Permit Application Review

Permit No. 2020-11  
Received complete: February 5, 2020

Applicant: Gary Wallace; Greystar Real Estate Partners  
Consultant: David Bade; Westwood Professional Services  
Project: Edina Promenade Residences  
Location: 3650 Hazelton Road: Edina  
Rule(s): 4,5,11,12  
Reviewer: BCO

**GRADING & EROSION CONTROL PLAN**

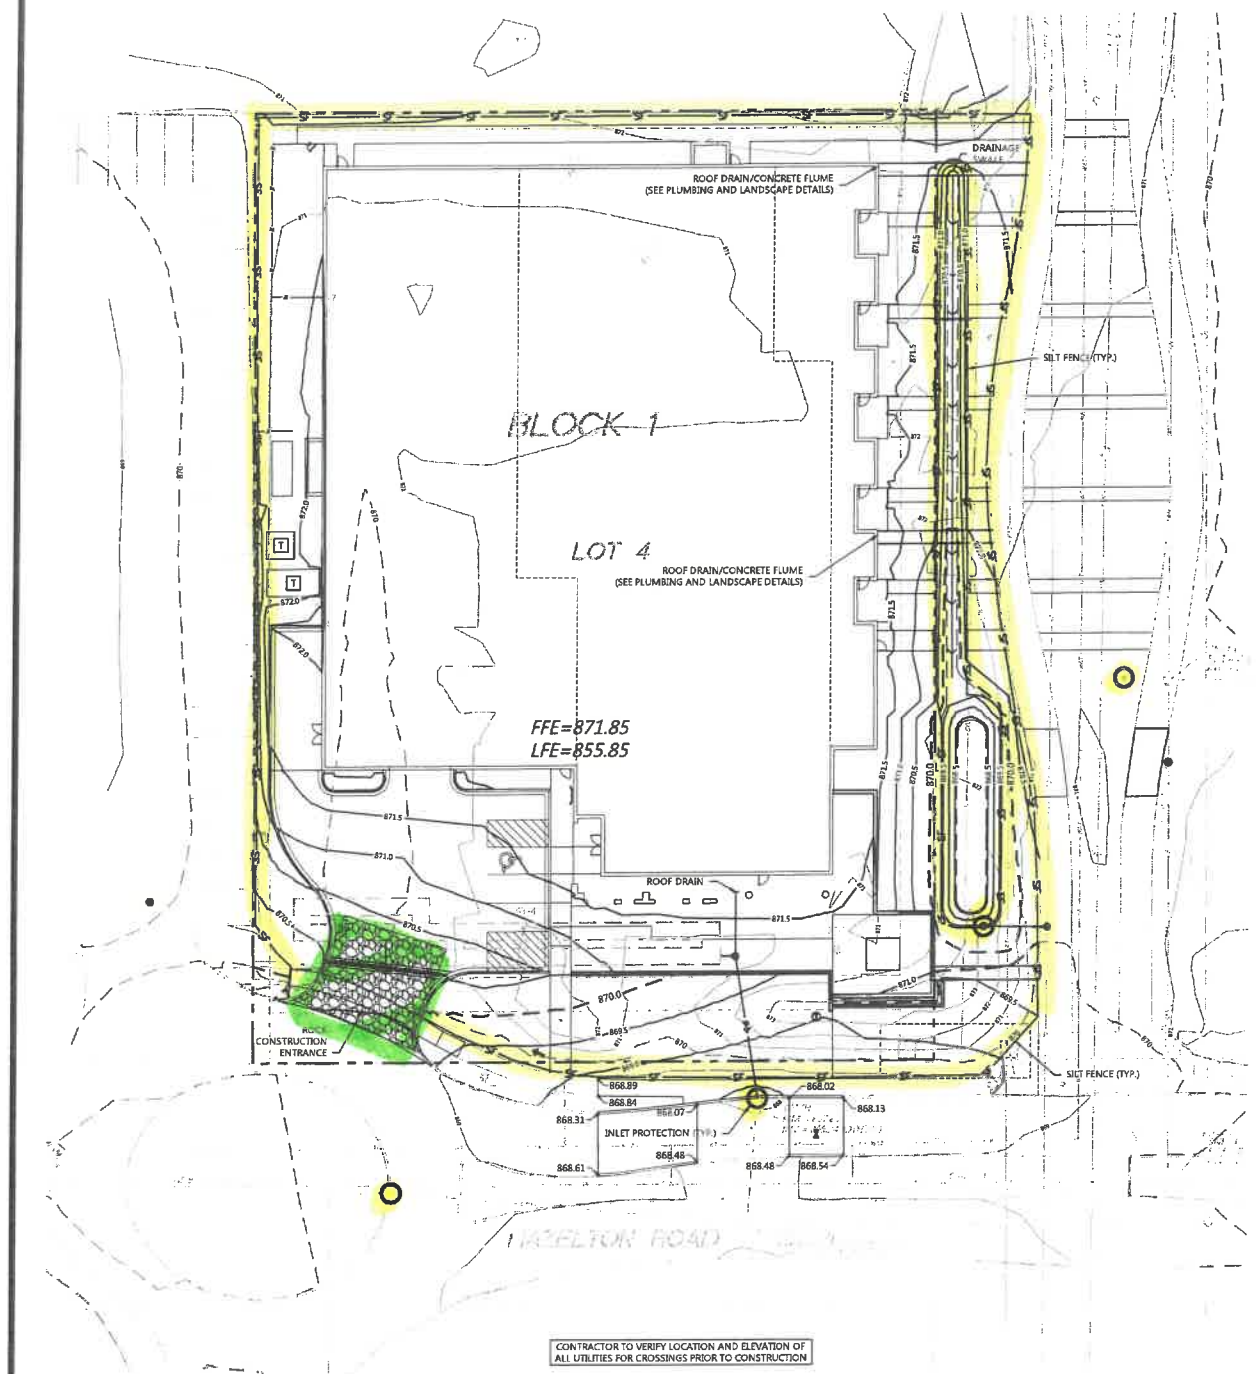
Silt fence is to be constructed at the limits of construction, inlet protection and a rock construction entrance will be provided for erosion control.

In accordance with Rule 4.3.1a (i), where below-ground infiltration facilities, practices or systems are proposed, pretreatment of runoff must be provided. The plans show that a sump manhole will provide the pretreatment of storm water upstream of the UGSWMF and the rock foundation material will provide the pretreatment for the pavers. Pretreatment will be required upstream of the rainwater garden.

The submitted erosion and sediment control plan includes silt fence at the limits of construction, inlet protection and a gravel construction entrance. The project contact is David Bade, Westwood Professional Services.

1. General Conditions
2. Financial Assurance in the amount of \$35,500 - \$30,500 for storm water management, erosion control and site restoration and \$5,000 for compliance with the chloride management requirements.
3. Submission of documentation that a drainage easement over the storm water-management facility has been submitted to Edina (4.5.4i), if such easement is required by the city, and a receipt showing recordation of a maintenance declaration for the on-site storm water management facility. A draft of the declaration must be approved by the District prior to recordation.
4. Submittal of a revised plan showing that pretreatment of runoff will be provided upstream of the proposed rainwater garden to comply with Rule 4.3.1a (i). Constructing manhole OCS-102 with a sump would comply with this requirement.
